TTE TECHNICAL INFORMATION

TV 08-001

CHASSIS: P810

TOPIC : PCB Main Board (Digital Board) Failure

Figure 1: PCB MAIN BOARD

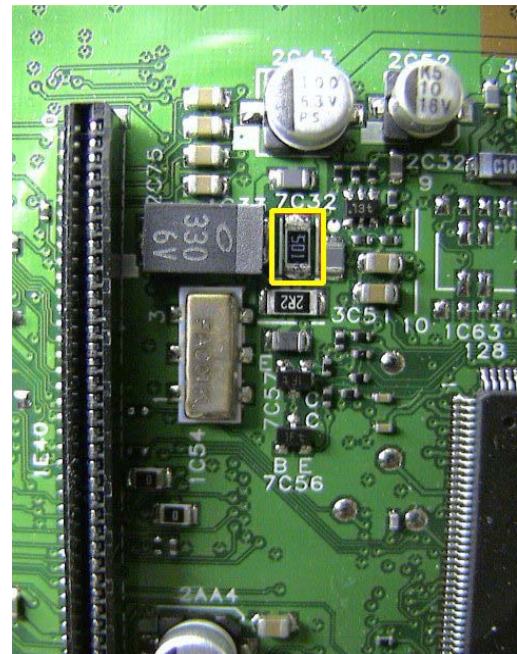
Symptom: No analog channels, distorted or lost audio, digital channels still present.

Cause: Open Fuse, 1C33, on PCB Main Board

If the customer complaint is "Distorted or no audio, no analog channels or analog inputs, but digital channels are still present" inspect the PCB Main Board (Digital Board) for an open fuse. The fuse, 1C33, is located approximately 2 inches behind the tuner (see Figure 1). The surface mounted part has various markings on the original part from "105" to "F" (see Figure 2 close-up) and is located below the board marking "7C32". An open fuse, 1C33 in the +5VMPIF-MAIN supply, has been found to be the cause of the listed problems. Replacement fuse #275819 can be placed directly over the top and soldered to the ends of the existing fuse to lessen the chances of damaging the board traces.

Cure: Install replacement fuse part #275819
